**STAFF REPORT
FOR THE PLANNING COMMISSION**

FILE NUMBER: PUD-14-02/SUB-14-02
HEARING DATE: November 5, 2014
REQUEST: 6-lot planned unit development (PUD) and subdivision at 2900 Haskins Road.
APPROVAL CRITERIA: Community Development Code (CDC) Chapter 11, Single-Family Residential Detached, R-10; Chapter 85 Land Division General Provisions; Chapter 24, Planned Unit Development.
STAFF REPORT PREPARED BY: Peter Spir, Associate Planner

Stoneking Place
Planned Unit Development

Tentative Plan

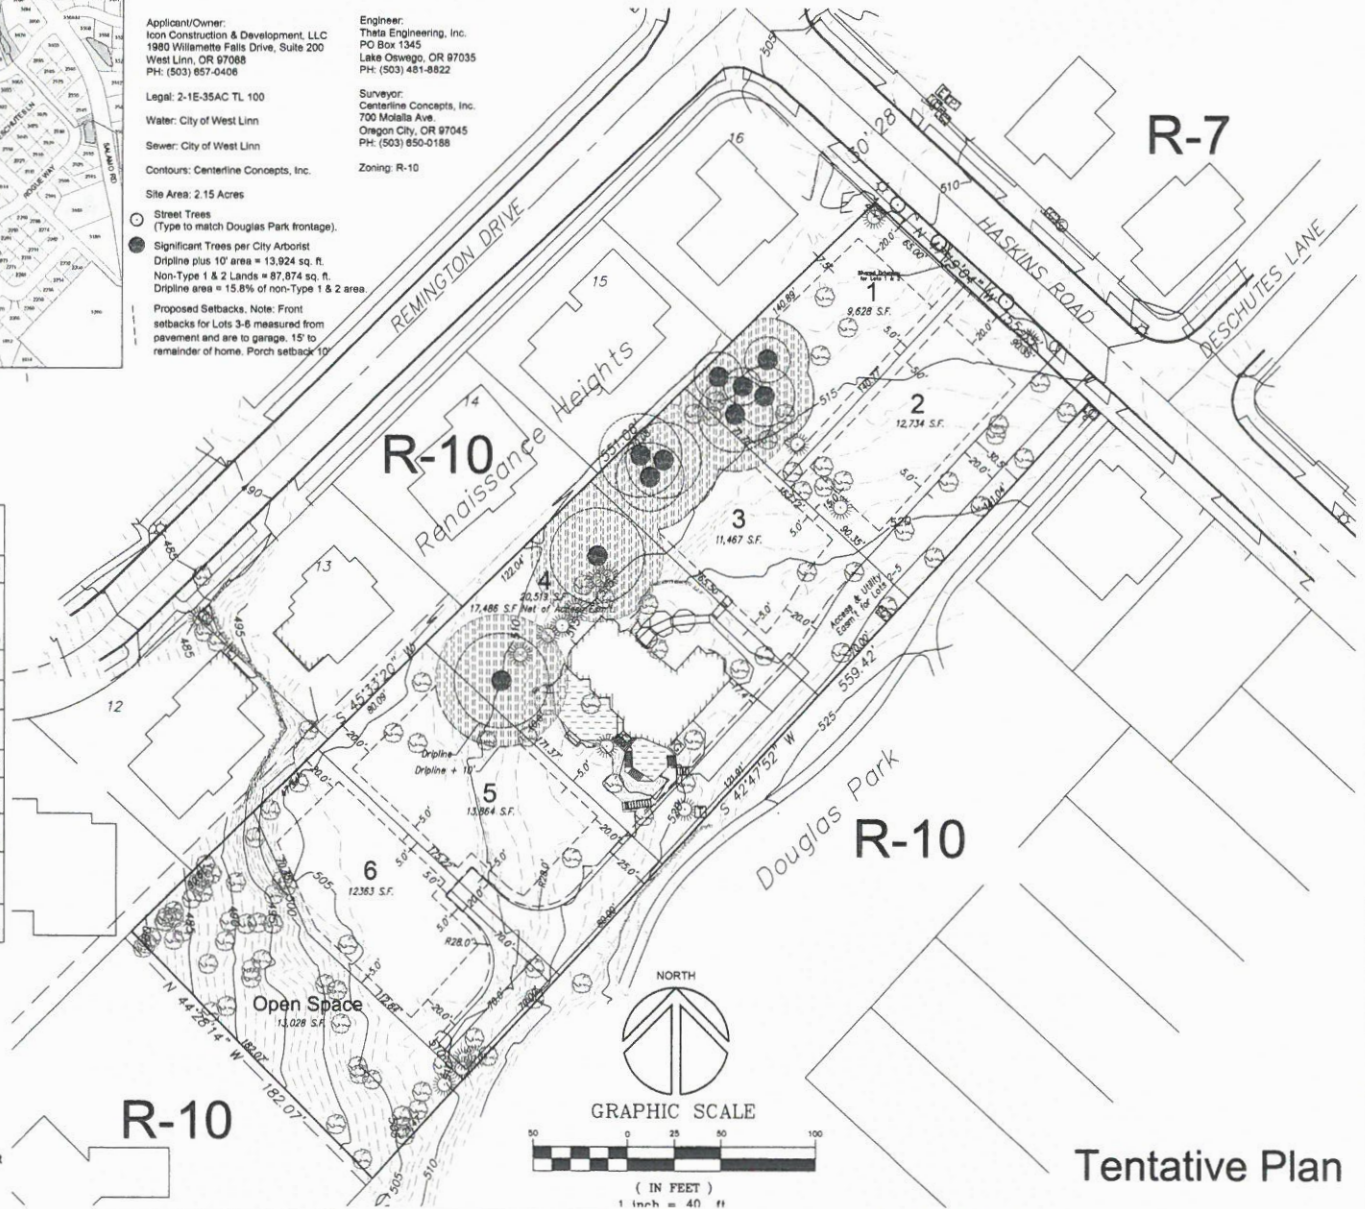
Staff Response 23: The site is in the R-10 zone where the minimum lot size is 10,000 square feet. Sheet 1 / 2 "Tentative Plan" includes a table which explains that, after deducting 10,000 square feet for the existing house, and allowing for the sloped type I and II lands, an additional six lots could be developed. Only six are proposed (exclusive of the open space). This amount meets the 70 percent density requirement. Therefore the criteria are met.

Staff Response 30: The applicant proposes to meet the dimensional, height and lot coverage standards of the underlying R-10 zone with the exceptions identified on the Tentative Plan (sheet 1 / 2). Those exceptions are for setbacks that are not contiguous to the perimeter of the site. For example, lot 2 proposes a 15 foot rear yard setback which is below the R-10 setback of 20 feet but is in agreement with the default setbacks of 24.180 (D) (4) above. All neighboring homeowners may be assured that the standard setbacks of the R-10 zone (e.g. 20 foot rear and 7.5 foot side) will apply for those yards that are contiguous to their properties. (See also Staff Response 25).

TENTATIVE GRADING AND EROSION CONTROL

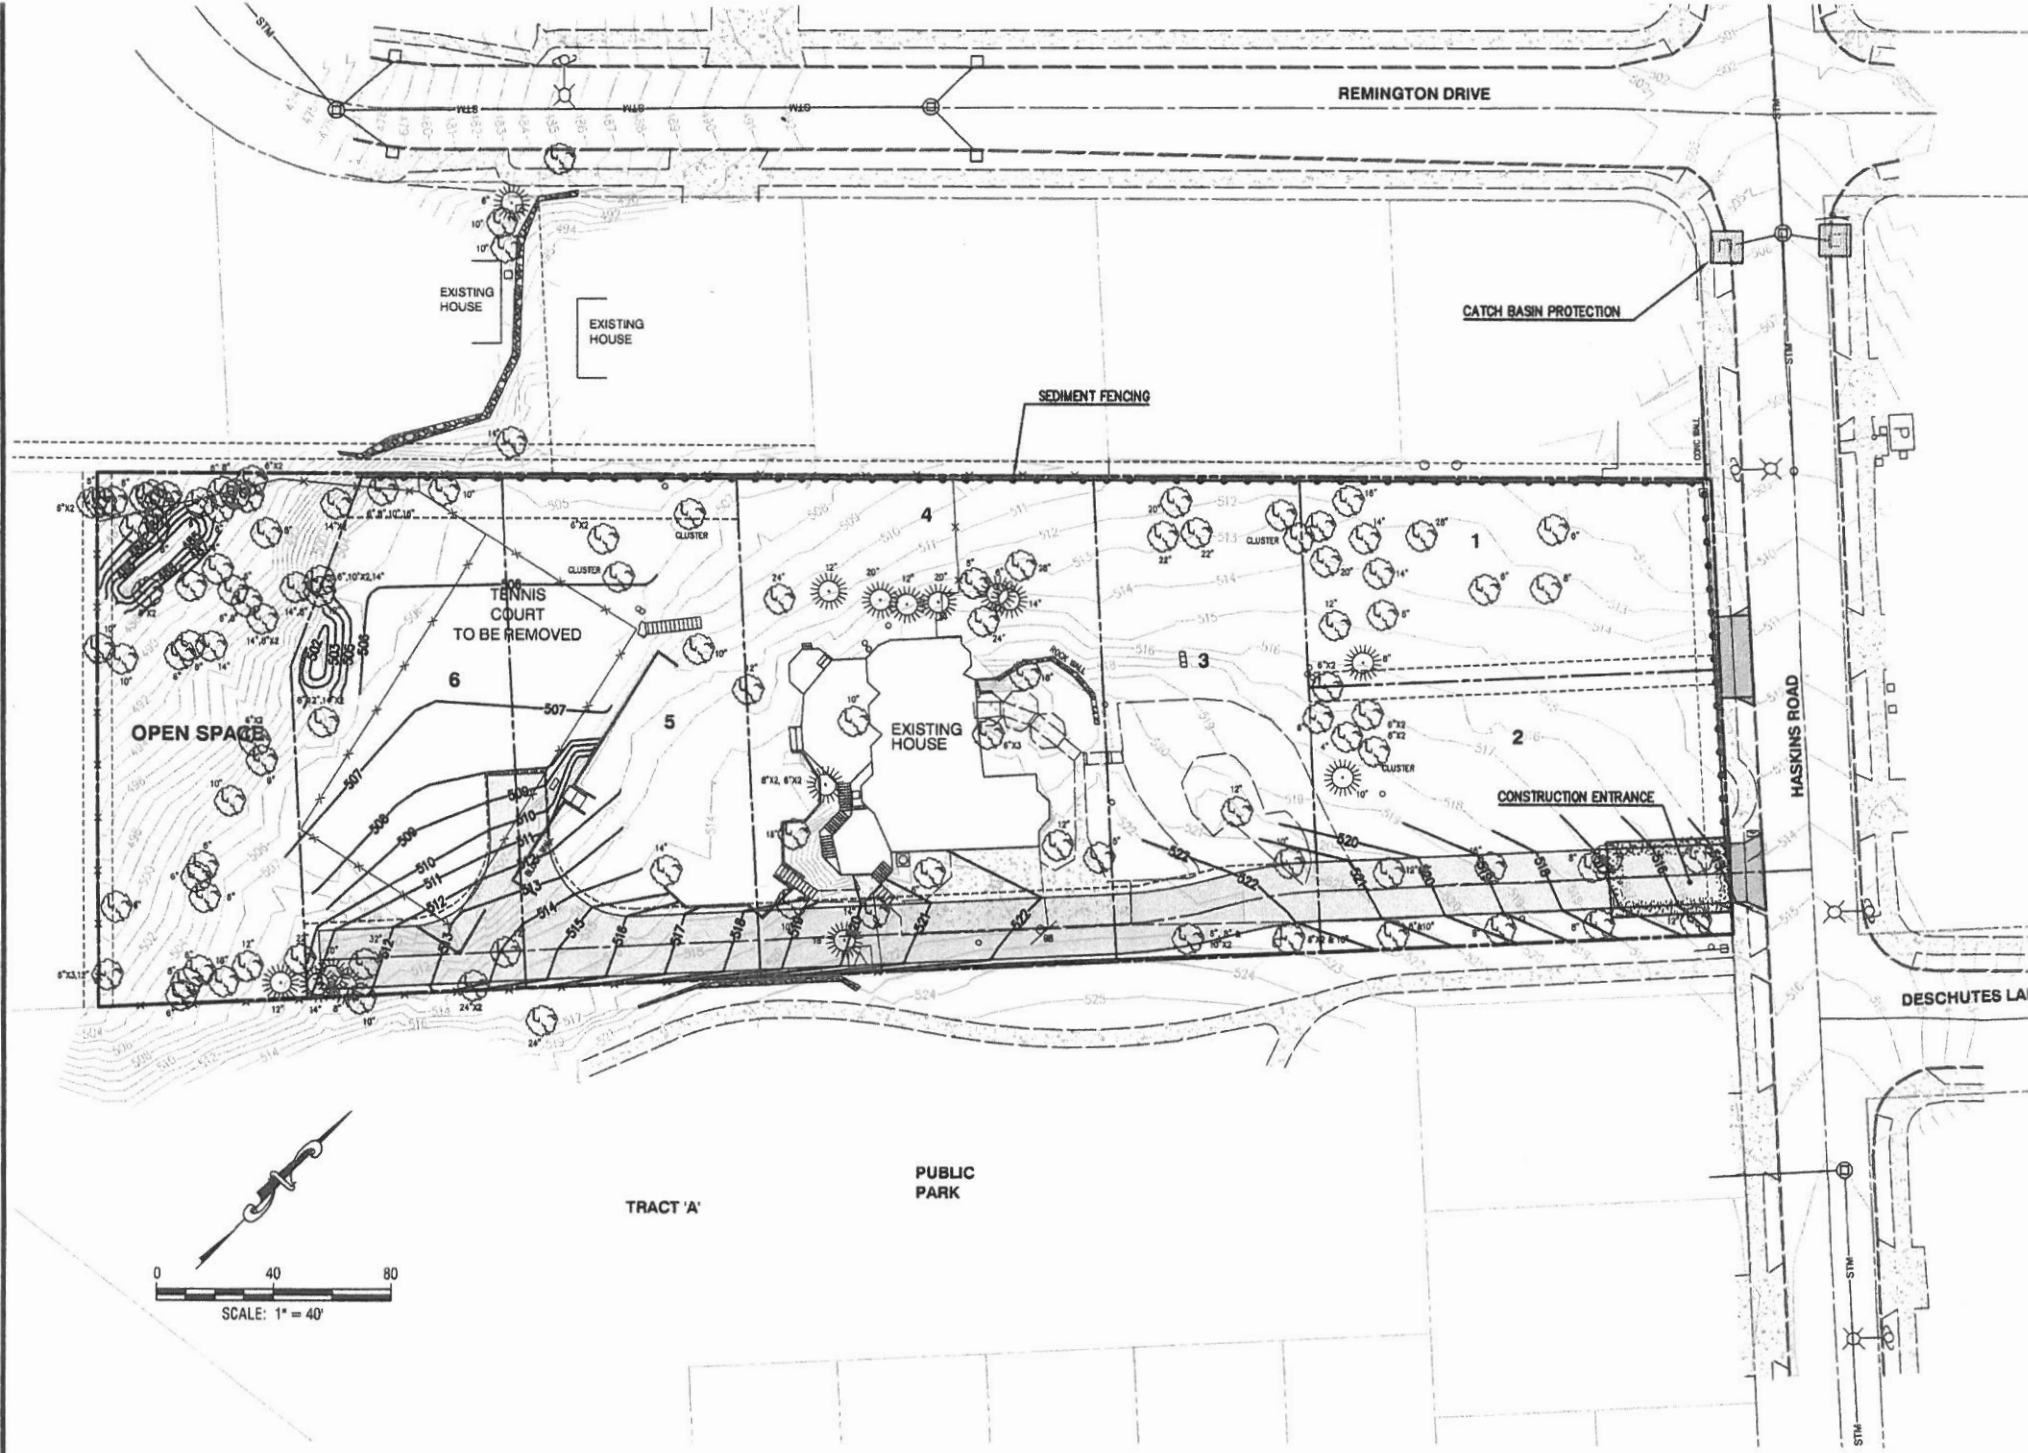
Staff Response 15: The Tentative Grading and Erosion Control Plan (Sheet 3/3) shows limited grading to facilitate construction of a wider shared driveway and hammerhead turnaround. The driveway width of 20 feet is the minimum allowable width to accommodate TVFR access. Driveway grades will have a maximum grade of 5%. Grading will not extend into the open space tract. The criteria are met.
